Addendum # 3

Bid Opportunity: 26-7848-RFT - Waterloo Collegiate Institute HVAC and Exterior Upgrades Phase 2

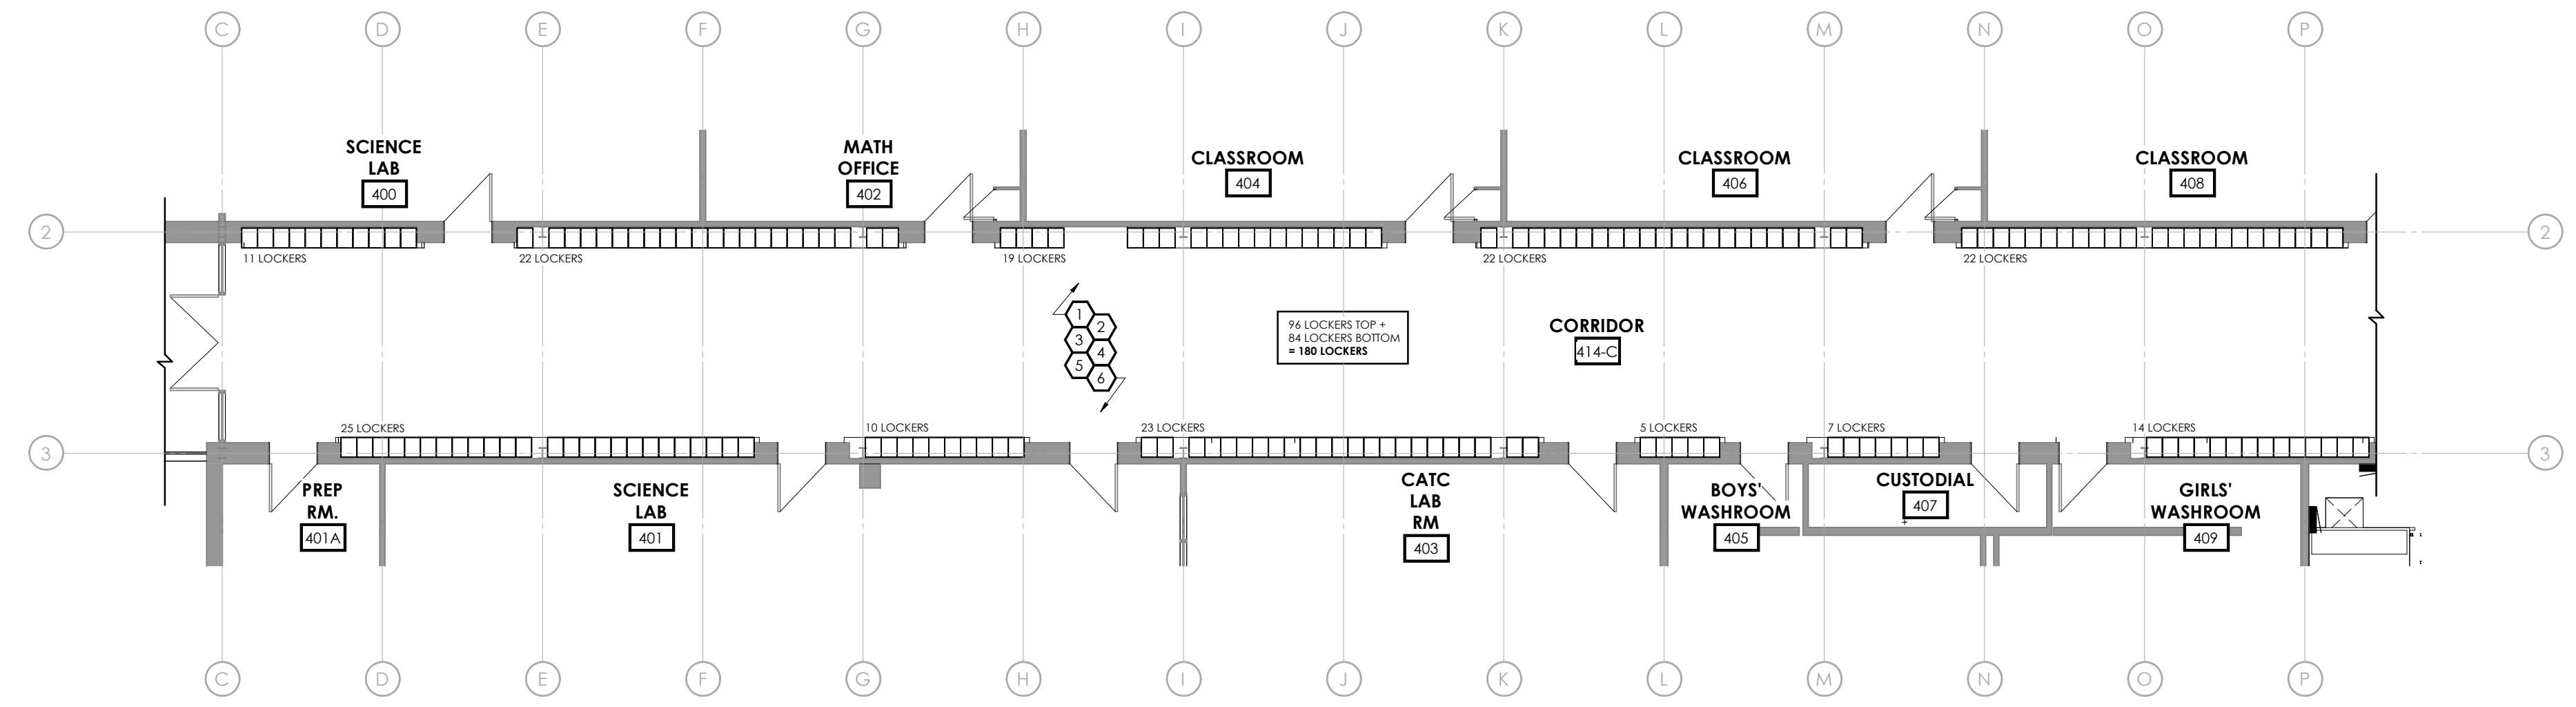
- .7 Doors: Fully enclosed at rear with a flush minimum ²⁰~~27~~ gauge thick reinforcing sheet to form a closed box and make a rigid, whip-free unit. Face of door to be free from protruding handles, locks, louvers, etc.

SCALE	As indicated	DRAWING NUMBER	A4.2
SHEET SIZE	609 x 914	PROJECT NUMBER	
PROJECT NUMBER	2025-153

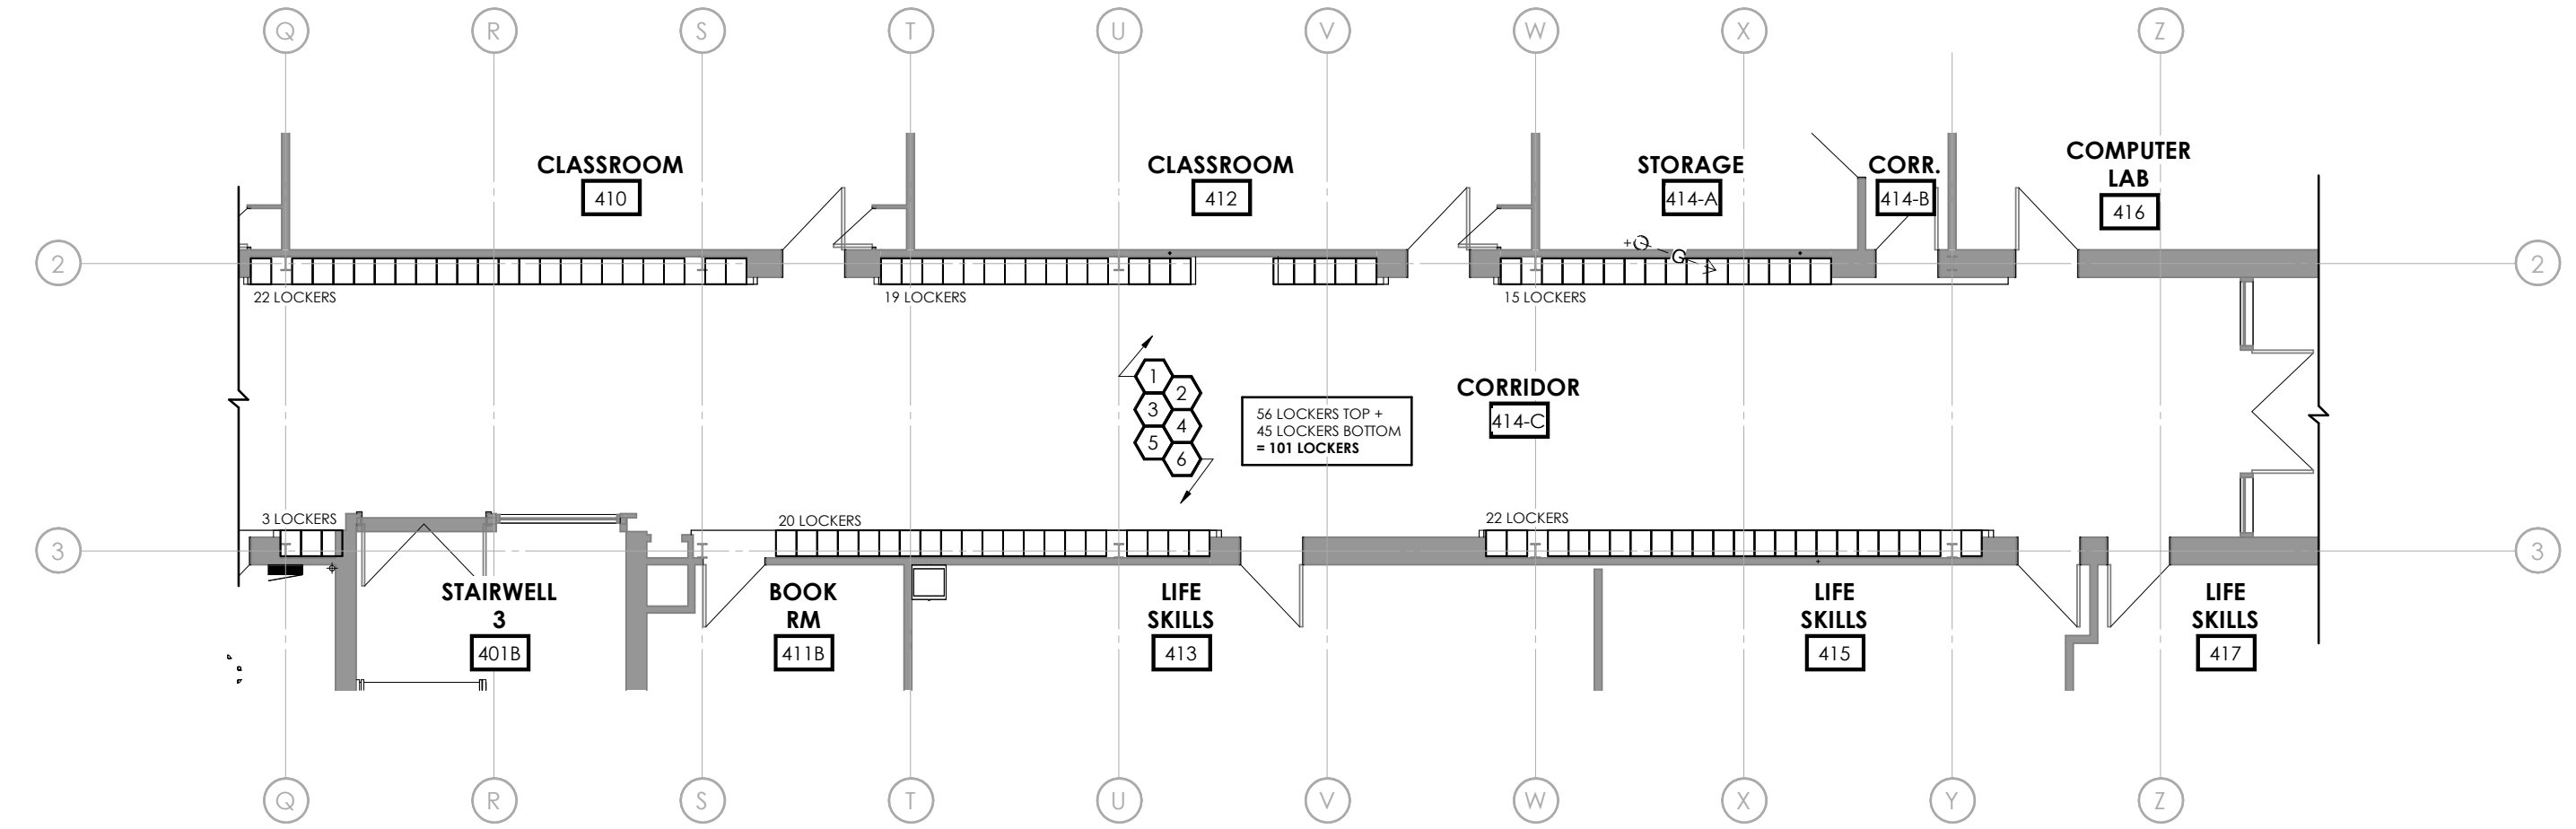
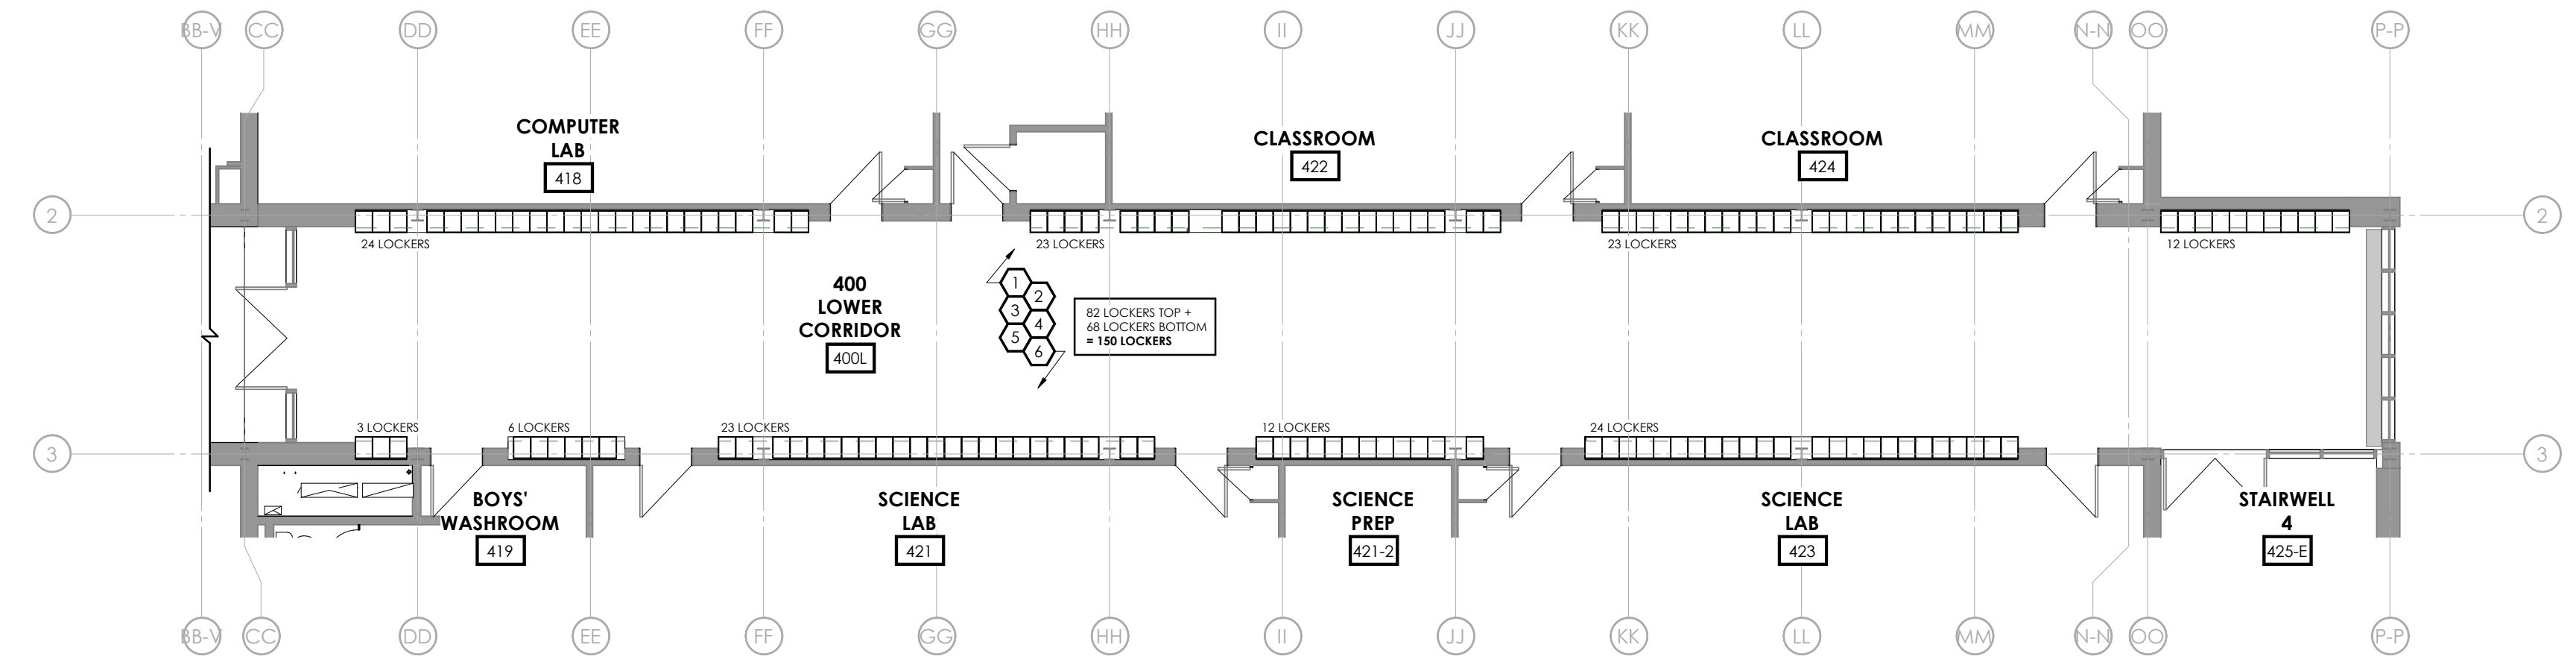
Reference Drawing, A4.1 identifies 1. Existing to remain locker bodies, including shelves, exposed interior, exterior. 2. All lockers missing hooks to receive new hooks. 3. New Locker Doors to be installed on all existing locker bodies. The Locker Keynotes, identify Replace Missing Hooks, and Supply new Doors. Under Electric Painting - identifies Locker bodies to be painted. Please confirm interpretation of Locker Keynotes, Painting, and New Fronts.

Refer to drawings A4.1 and A4.2 dated 2026.03.23, attached, and forming part of this addendum.

- EXISTING TO REMAIN LOCKER BODIES, INCLUDING SHELVES, EXPOSED INTERIOR CORNER AND FILLER PANELS, TO RECEIVE NEW ELECTROSTATIC PAINT FINISH.
- ALL LOCKERS MISSING HOOKS TO RECEIVE NEW HOOKS. STYLE AND LOCATION / HEIGHT TO MATCH EXISTING. REFER TO SPECIFICATIONS.

- REMOVE AND DISPOSE OF EXISTING LOCKER DOORS. NEW LOCKER DOORS TO BE INSTALLED ON ALL EXISTING LOCKER BODIES. CONTRACTOR TO SITE VERIFY LOCKER SIZES PRIOR TO ORDERING. STYLE AND COLOUR TO MATCH LOCKER DOORS IN CORRIDOR OF WING 'A' UPPER 300 LEVEL.

- ALL LOCKERS TO RECEIVE NEW RAISED BASE PANS OVER EXISTING BASE. COLOUR TO MATCH NEW LOCKER FINISH.
- ALL SHEET METAL INFILL PANELS OVER COLUMN LOCATIONS, ABOVE LOCKERS, TO RECEIVE NEW RAISED CAPS. TO RECEIVE NEW ELECTROSTATIC PAINT FINISH. COLOUR TO MATCH NEW LOCKER FINISH.
